City of Sugar Hill Planning Staff Report DRB TCO 17-01893

Town Center Overlay (TCO) Design Review

1329 & 1335 Hillcrest Drive, Southern Heritage Home Builders

HILLCREST TOWNHOMES

PRELIMINARY HARDSCAPE

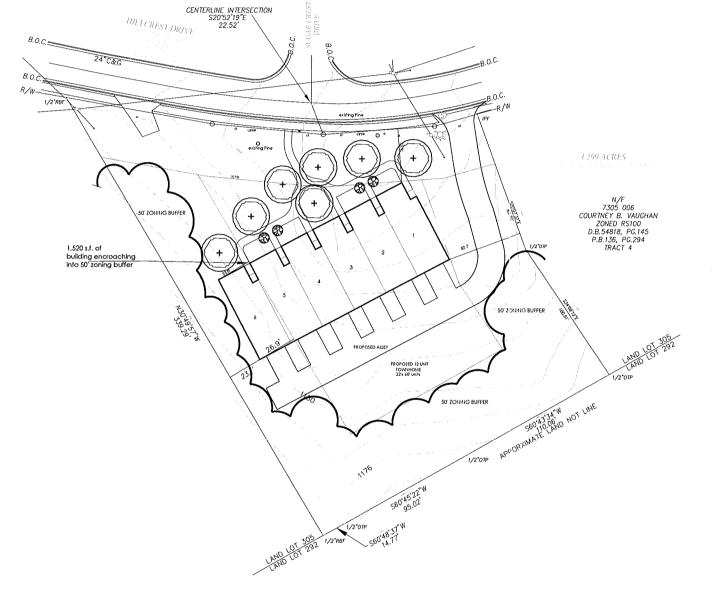
- 1. Provide pedestrian walkway from front doors of units to existing sidewalk along Hillcrest Drive.
- 2. A single common entry drive shall be aligned with the existing intersection at Hillcrest Glenn Drive.

- Rear entry or detached garages shall be provided. No front entry or individual driveways shall be allowed to directly access Hillcrest Drive.
- 4. Final design shall substantially resemble the attached elevations and site plan. Except minor deviations required to address project access in accordance with these conditions and material selection in compliance with the minimum standard.

- The general design, character, arrangement, materials, color, and scale of the building are compatible with the emerging character of the area. The site design and landscaping should be modified to contribute a more pedestrian-accessible streetscape by providing walkway from front doors of the units to existing sidewalk along Hillcrest Drive. A single common entry drive shall be aligned with the existing intersection at Hillcrest Glenn Drive.
